Notice of Allowability	Application No.	Applicant(s)	
	10/826,467	VAN ZANTEN, FRANCOIS	
	Examiner	Art Unit	
	Henry K. Choe	2817

DETAILED ACTION

Reasons for Allowance

Fig 1

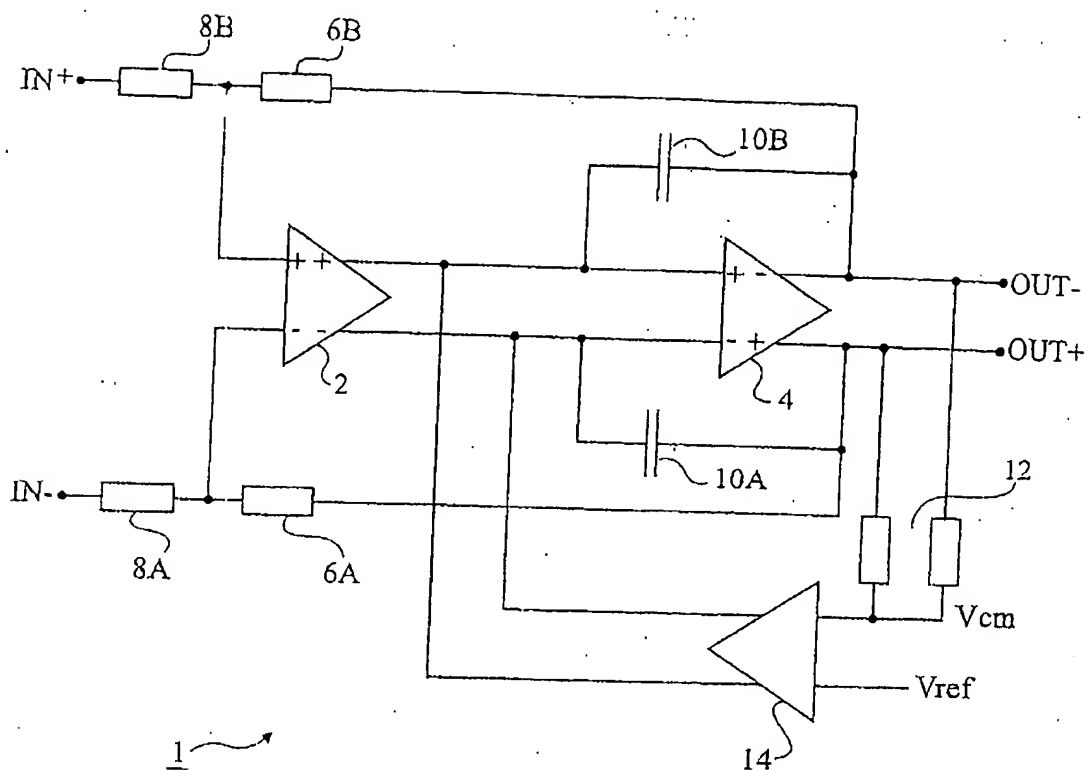
It should be noted that the applicant filed the new Figure 1 of drawing on 2/8/06.

The following is an examiner's statement of reasons for allowance: Regarding claim 1, the closest prior art of record, applicant's admitted prior art (Fig. 1 of drawing) does not disclose the following limitations: the functional limitations of the means. Regarding claims 11, 15 and 21, the closest prior art of record, applicant's admitted prior art (Fig. 1 of drawing) does not disclose the following limitations: Operable in a cutoff mode when the input signal is near a cutoff frequency to inhibit the development of the common mode feedback value on the output. Regarding claim 24, the closest prior art of record, applicant's admitted prior art (Fig. 1 of drawing) does not disclose the following limitations: Disabling application of the feedback value to the input of the amplifier when the frequency of the input signal is near the cutoff frequency.
